NZ 189/12 SOUTHERN OCEAN – Ross Sea – Depths.

Chart NZ 14065 (INT 65) [235/05]

New Zealand Hydrographic Authority
 NI 218/2012

<i>Issued as a guide to chart correction.</i>		<i>Use in conjunction with the appropriate NZ Notice to Mariners.</i>	
LAST CORRECTION	NZ NTM No.	CHART No.	
NZ 235 /05	NZ 189/12	NZ 14065 (INT 65)

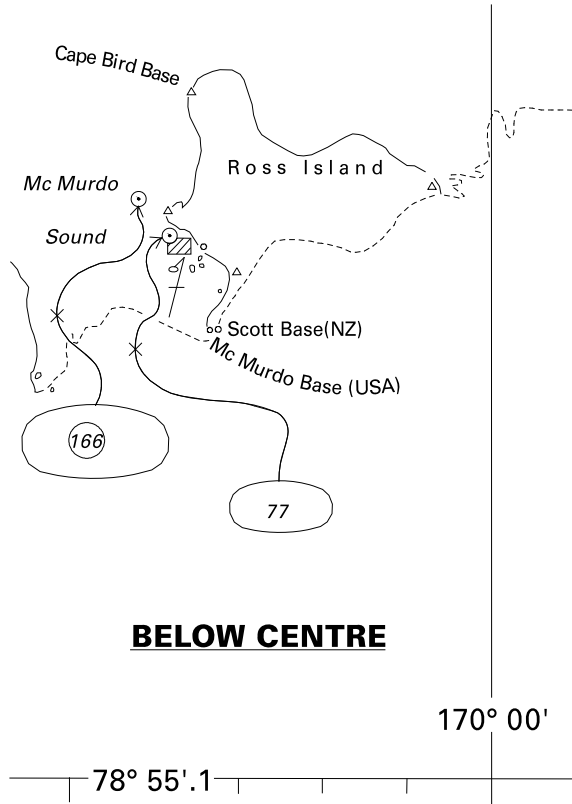
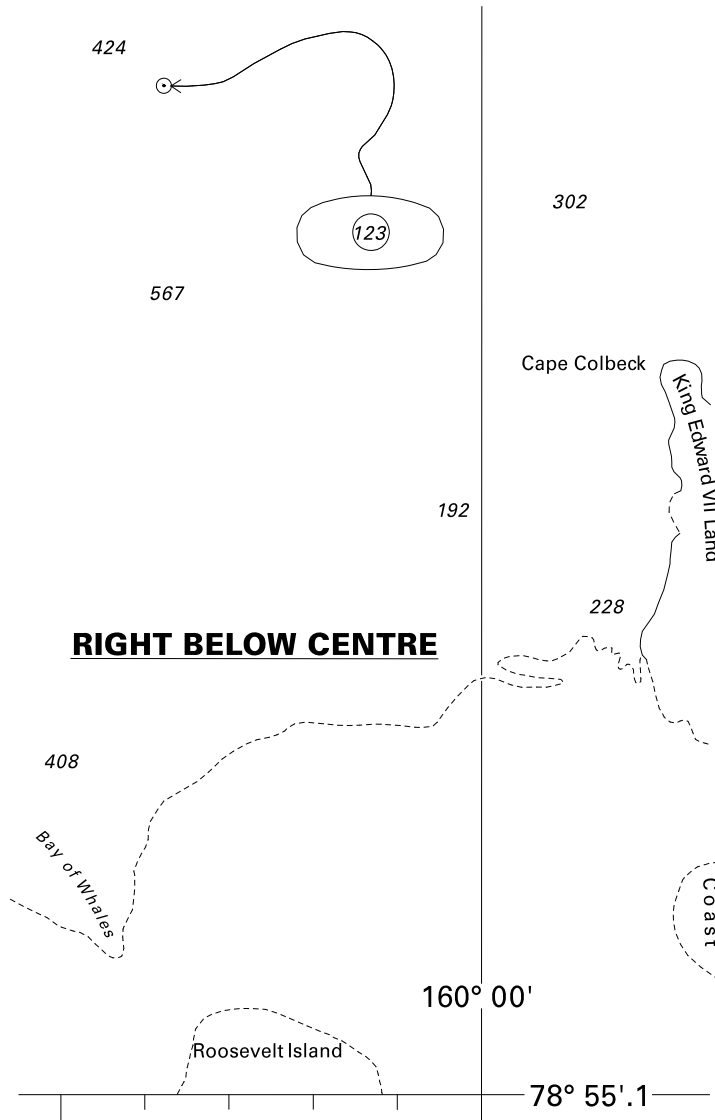
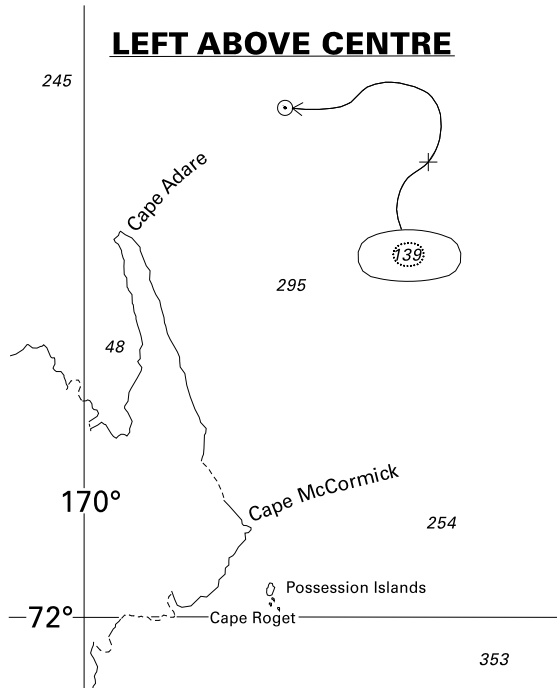
Insert		71° 03'.48S., 171° 10'.36E.
	depth 123, enclosed by 200m contour	76° 21'.69S., 163° 46'.38W.
	depth 166, enclosed by 200m contour	77° 30'.89S., 165° 48'.86E.
	depth 77	(a) 77° 36'.53S., 166° 10'.95E.
Delete	depth 121, close SE of:	(a) above

<i>Issued as a guide to chart correction.</i>		<i>Use in conjunction with the appropriate NZ Notice to Mariners.</i>	
LAST CORRECTION	NZ NTM No.	CHART No.	
NZ 92/12	NZ 189/12	NZ 14900 (INT 900)

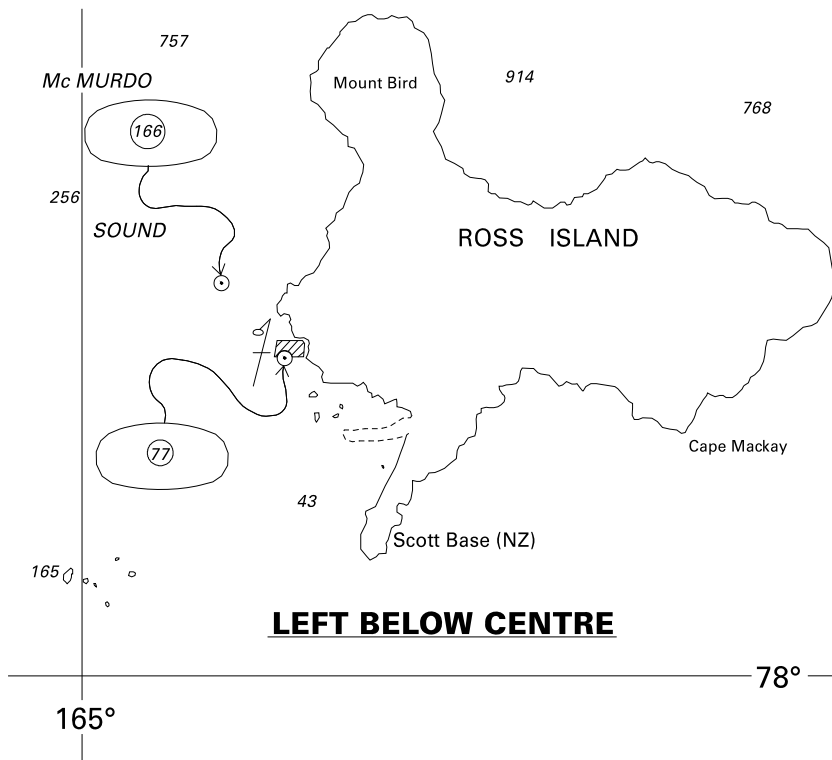
Insert		71° 03'.48S., 171° 10'.36E.
	depth 166, enclosed by 200m contour	77° 30'.89S., 165° 48'.86E.
	depth 77, enclosed by 100m contour	(a) 77° 36'.53S., 166° 10'.95E.
Delete	depth 110, close NE of:	(a) above
